**Original Report to LPP - 27 April 2022**

**Item 5.****Development Application: 5 Victoria Road, Glebe - D/2021/865**

File No.: D/2021/865

**Figure 45:** Maximum height proposed

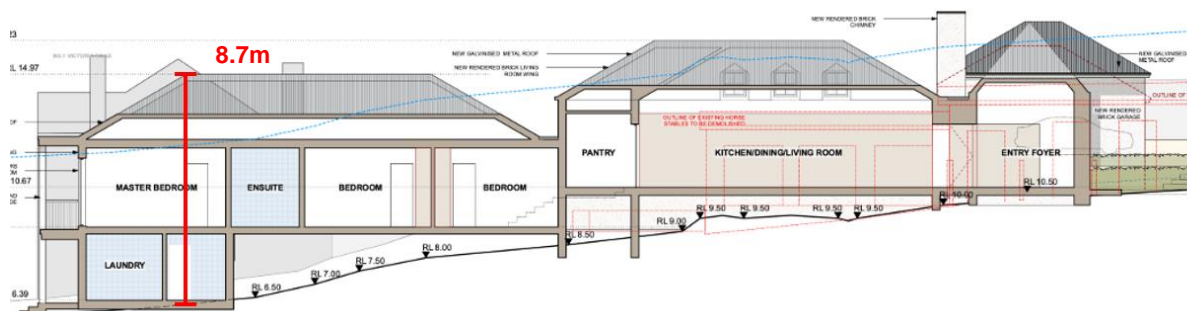
37. The site is subject to a maximum height control of 6m. The proposed development has a maximum height of 8.7m, consisting of the roof ridge of the new dwelling (Dwelling 2). The proposal comprises a 45% breach of the height standard.
38. It is noted the existing building on site (Dwelling 1) has a maximum height of approximately 10m to the top of the roof ridge, which represents a 66.6% exceedance. See Figure 45 below demonstrating the point of the maximum height breach.

**Figure 51:** Detail of north-east elevation showing outline of stables building in red dash and extent of new development above the existing roof height of the stables. Maximum height breach of foyer roof circled in pink; breach of middle roof circled in green.

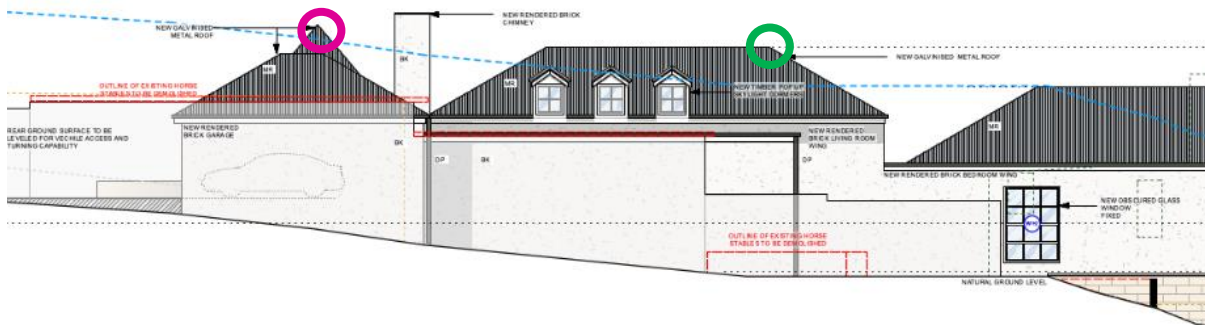
- (f) The north-east elevation drawing below (Figure 51) includes the outline of the stables building to be demolished, shown in a dashed red line. At its highest points (to the apex of the roof above the entry foyer, and to the roof ridge of the middle portion of the house), the new building and roof extend around 2.6m above the roof height of the existing stables structure. The proposed chimney extends approximately 3.2m in height from its junction with the roof below, however it is noted that the LEP definition of building height excludes chimneys.
- (g) With regard to exceedance of the height standard in areas suggested as contributing to view loss, given the natural slope of the land, the breaches are as follows:
  - (i) 450mm from the apex of the roof of the foyer (7.5% breach); and
  - (ii) 1200mm from the apex of the roof ridge of the middle portion of the building (20% breach).

- (h) Figure 51 suggests around 2-2.5m of space above the roof of the stables will comprise of roofscape. This will likely obstruct sightlines to Jubilee Oval currently available to the rear of 14 Alexandra Road.

**Figure 53:** South-east (facade) elevation of Dwelling 2, showing roof ridge's minor exceedance of 6m height control. Noting chimneys are excluded from building height.

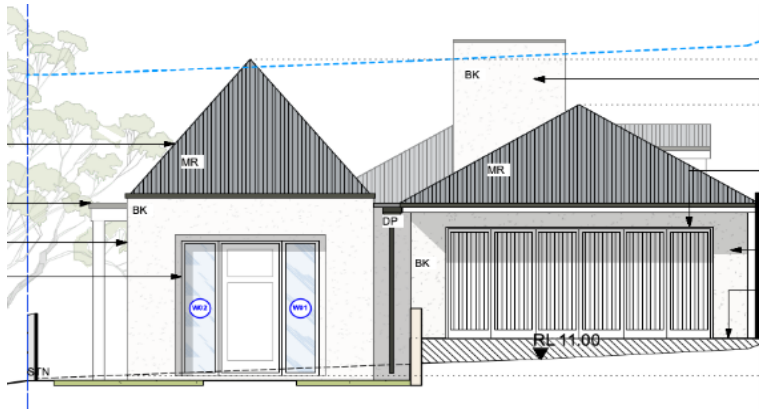
- (l) The proposal complies with the LEP’s FSR standard but breaches the height control. Tenacity states that “where an impact on views arises as a result of non-compliance with one or more planning controls, even a moderate impact may be considered unreasonable.”
- (m) The maximum height breach of 2.7m or 45% is a direct result of the design of Dwelling 2 – in particular, its roofing. The pitched, hipped design of the roof proposed ensures the development respects and is sympathetic to its highly prominent context adjacent to Jubilee Park and within the Toxteth heritage conservation area. It is noted that given the slope of the site, only 600mm to 1200mm (7.5% and 20% exceedances respectively) of the roofing exceeds the 6m height limit in the area of the development which may impact sightlines.

**Figure 54:** North-east elevation of Dwelling 1 (right of image) and of No. 3 Victoria Road (left of image) - W03 identified in red dash

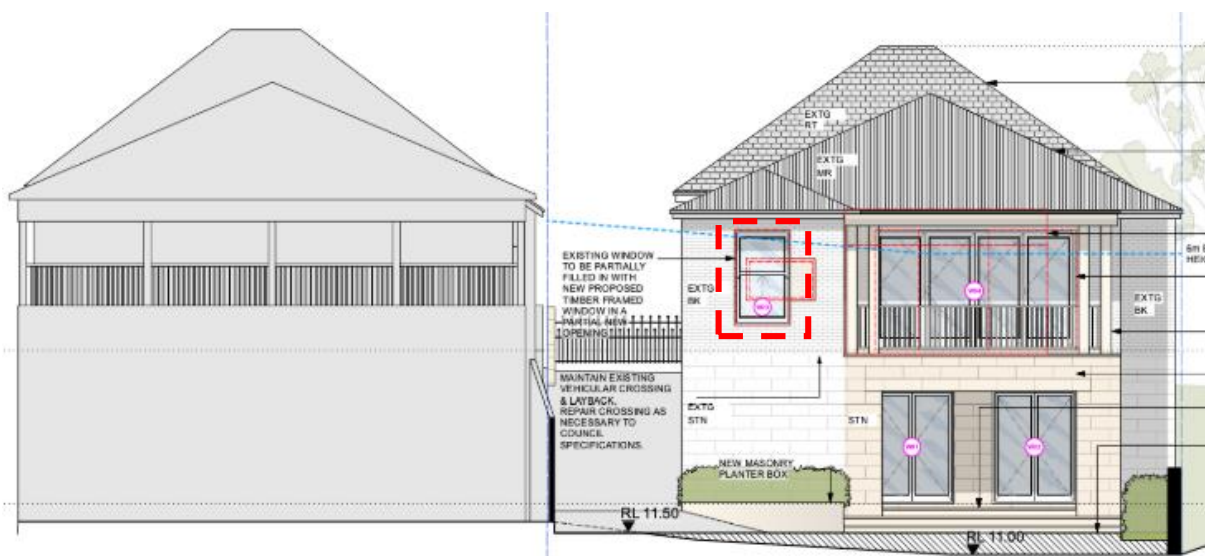
78. Changes to the rear first floor of the existing dwelling (Dwelling 1) include alterations to window W03 to be a vertically proportioned sash window. The window is proposed to have a sill height of 0.7m and is to feature clear glazing. The same change is proposed to W06 on the north-east elevation. See Figures 54 and 55 below.
79. The rear first floor terrace also includes full height glazed bifold doors (W04) to the north-east elevation, and new glazed doors (W03) to the south-west elevation.

**Figure 58:** W12 shown in red dash, dormer windows shown in blue dash

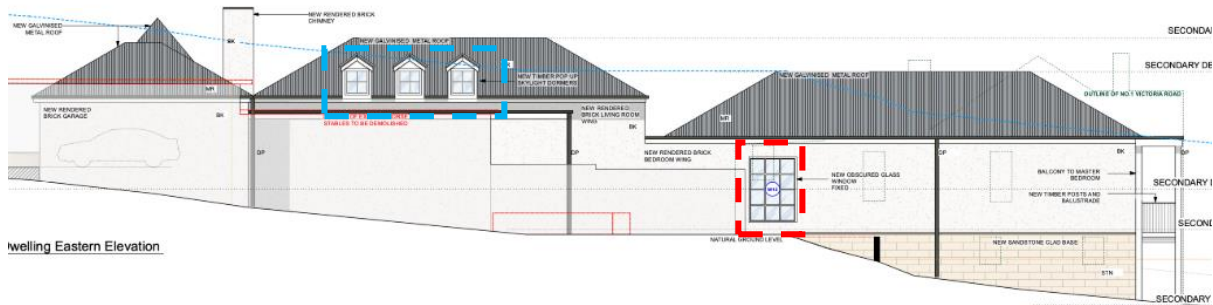
84. The proposal also includes windows to the north-east elevation, including a multi-paned window identified as W12 and three (3) dormer windows. See Figure 58 below.

85. Whilst Council's Urban Designer raised concerns about W12 and its proximity to the kitchen of its neighbour at 1 Alexandra Lane, an annotation on the elevation drawing indicates W12 is proposed to feature obscured glass and is intended to be fixed. The dormer windows are located in the roof of the development, which is single storey in the subject location. There is no means for overlooking to occur from these windows, as their sills are over 3.5m above finished floor level.

**Response:** As per discussion above in this report, the lower sill of the three windows is 3.5m above finished floor level. The windows as designed will not result in adverse overlooking impacts.

**Figure 59:** Site plan including trees

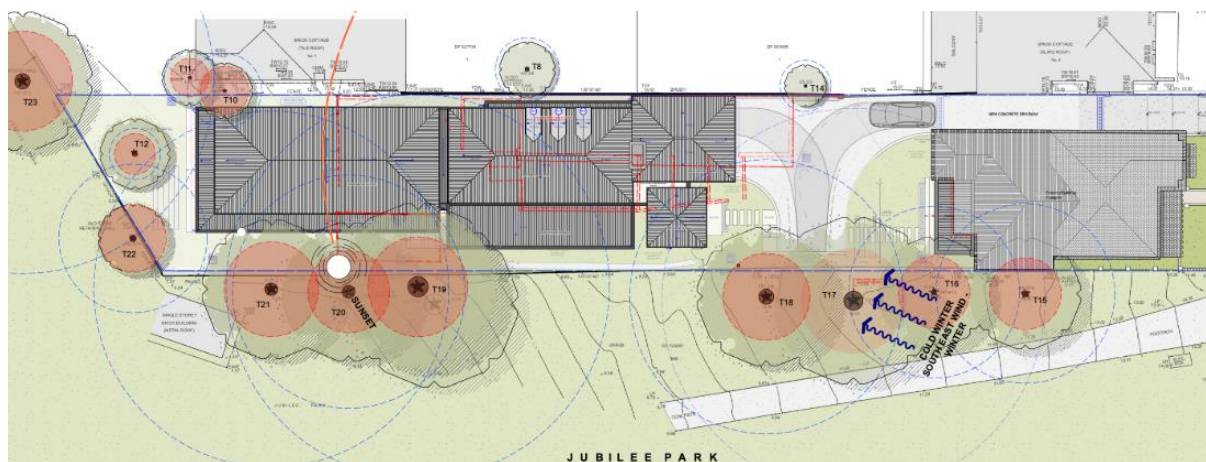
88. The trees most likely to be impacted by the development are shown in Figure 59 below.

89. Council's tree management officer has reviewed the proposal and made a series of recommendations to ensure trees on site and adjacent are adequately protected, including:

- (e) Provision of a 'Pruning Specification Report' and a 'Work Methodology' based on the most up-to-date plans be submitted, ensuring canopy loss is less than 5% and branches with a diameter greater than 100mm are not proposed to be removed.

92. Tree Management also recommended the inclusion of an advance tree planting condition requiring the planting of three (3) trees that will grow to 10m in height and have a canopy spread of 6m, to meet minimum canopy target requirements contained in Clause 3.5.2 of the DCP.
